# Technical Service Information

## FORD 5R55E OVERDRIVE DRUM SPEED (ODS) SENSOR ELIMINATED

Figure 1

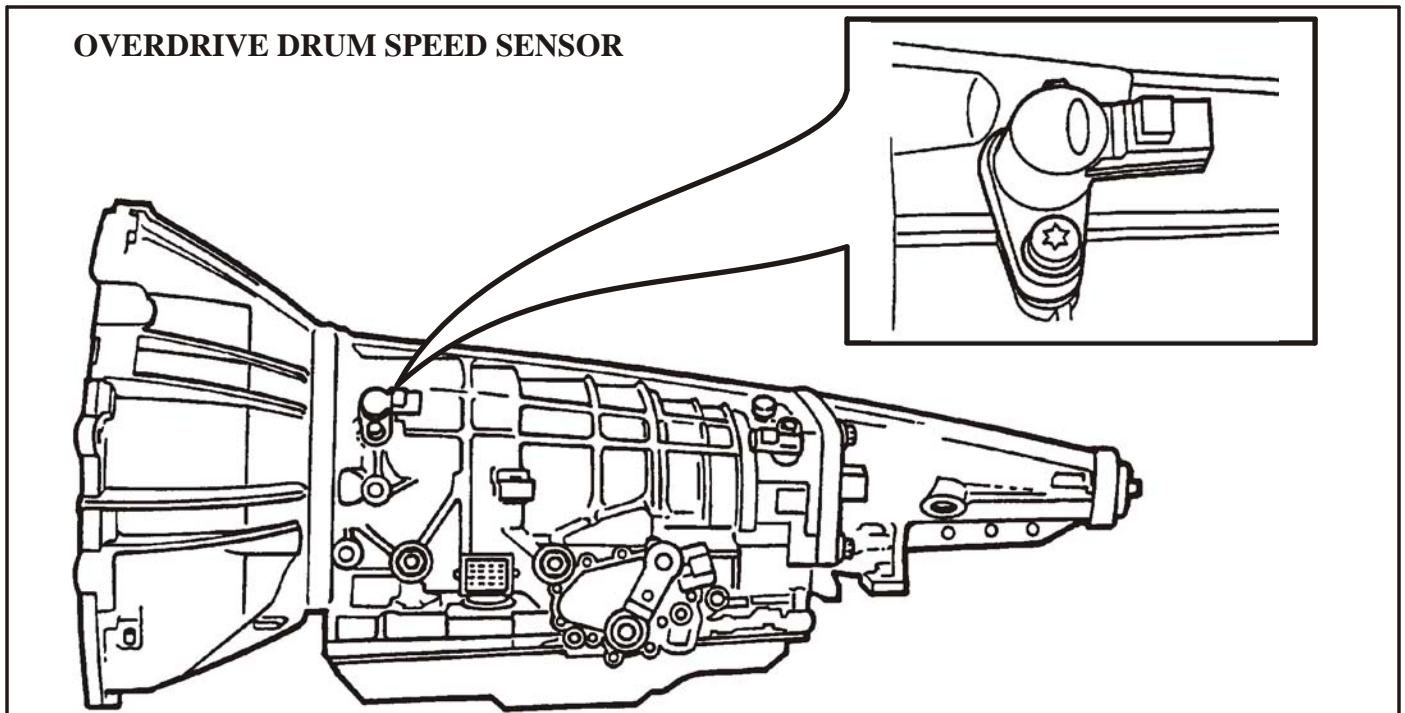
**CHANGE:** The Overdrive Drum Speed (ODS) Sensor, located in the transmission at the front of the case, was eliminated as a running change during the 1997 model year. Refer to Figure 1.

**REASON:** To eliminate erratic operation and malfunctions.

- (1) OVERDRIVE DRUM SPEED SENSOR - Eliminated during the 1997 production year.
- (2) TRANSMISSION CASE - New service cases will not have an Overdrive Drum Speed Sensor hole in the case. New service part number for the case is F77Z-7005-DB.

During the transmission rebuilding process, disconnect the ODS sensor connector, cut off the connector end and splice the wires together. Shrink wrap the wire ends and secure the wires to the harness with a tie-wrap. This should reduce the possibility of stray signals affecting the operation of the transmission. Leave the sensor installed if you are using the original case. The new service cases will not have the ODS sensor hole in the case.
